Toongabbie to Westmead Active Transport Corridor Feedback

Thank you for the opportunity to comment on the Toongabbie to Westmead Active Transport Corridor Draft Plan (*The Plan*).^[1]

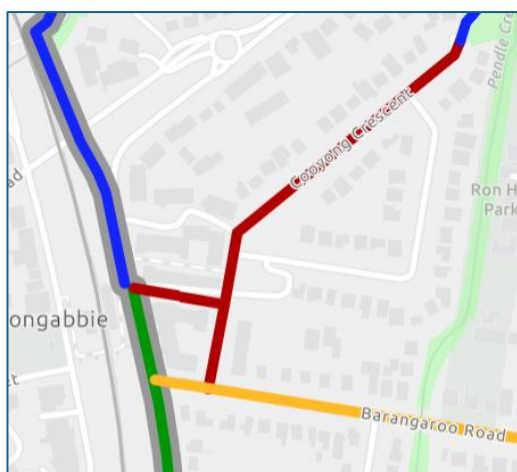
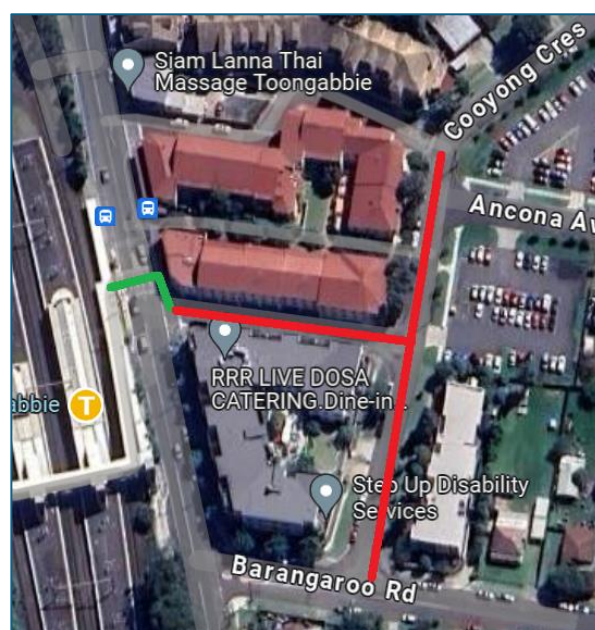
While *The Plan* facilitates a cycleway access point directly opposite Barangaroo Rd, bike riders will need to cross Wentworth Ave unassisted and watch out for potentially turning traffic into or out of Barangaroo Rd.

Another or an additional solution may be to modify the zebra crossing opposite Toongabbie station to a combined pedestrian and cyclist crossing, and let riders use Fettle Lane and Cooyong Crescent to access Barangaroo Rd.

b. Ballandella Rd.

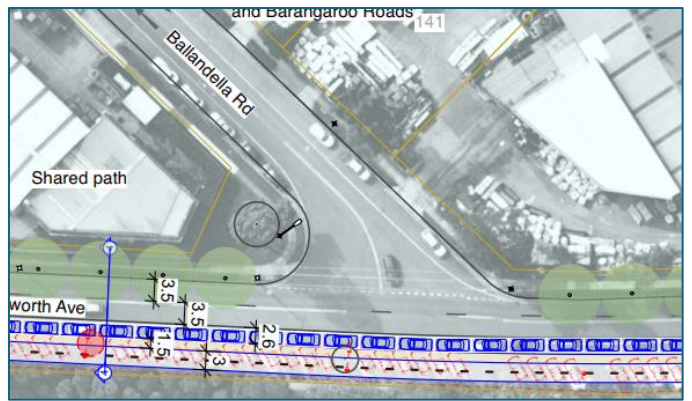
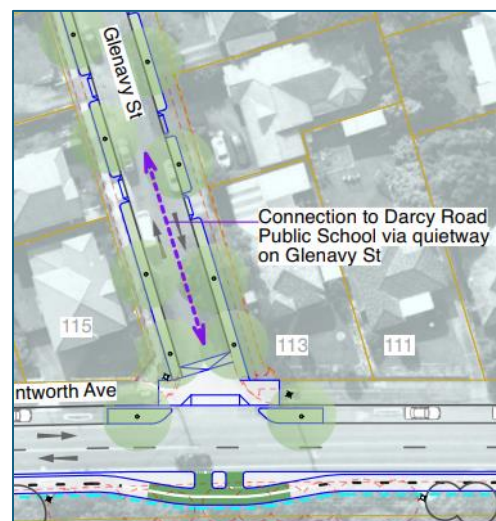
There is no allowance for an access point to the cycleway from Ballandella Rd.

Although marked as an ‘on-road’ cycleway, we’re not sure whether this was omitted as riders are supposed to use the shared-path alternative (which is not currently fully usable as a shared path) that accesses Wentworth Ave via Burrabogee Rd and its associated crossing.

No ready access to cycleway from Ballandella Rd

Marked-up screenshot of the Bike Plan, showing possible alternative access to the Wentworth Ave cycleway via Burrabogee Rd, which is proposed to have a crossing of Wentworth Ave.

2. Discrepancy between maps at Pendle Hill Railway Station Crossing

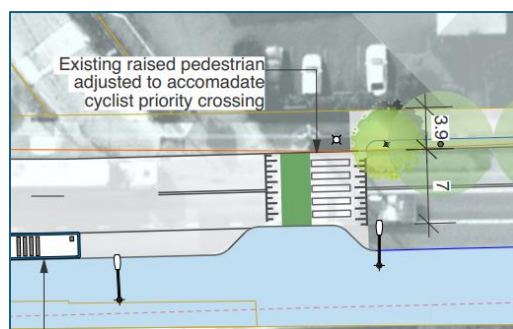
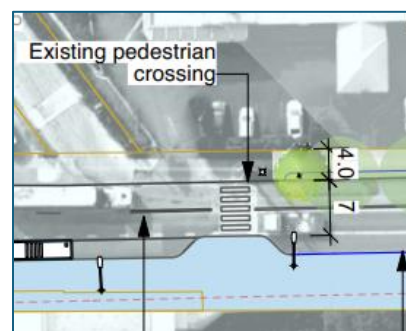
Note that on the detailed station plan, this crossing was identified as converting to a shared pedestrian and cyclist crossing, but on the larger map it remained as a pedestrian crossing.

If a cyclist crossing, there is no indication of what it would connect to on the other side of the road (i.e. No shared paths marked).

We're wondering whether the combined crossing was intended to be for Toongabbie Station rather than Pendle Hill. That would make more sense to us.

3. Bike Racks at Railway stations:

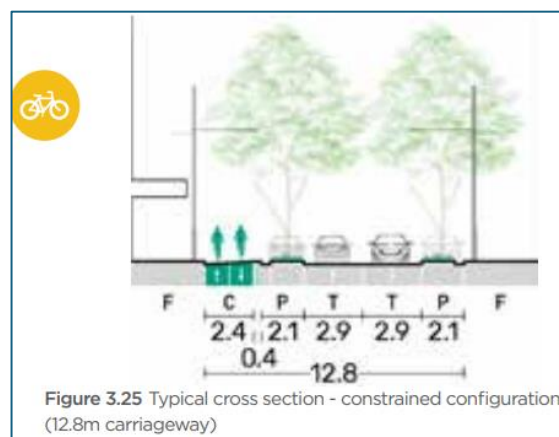
Just an observation that in the more detailed station diagrams there's bike racks specified for Wentworthville station, but we couldn't locate any for Toongabbie or Pendle Hill stations. Was this an omission or on purpose?
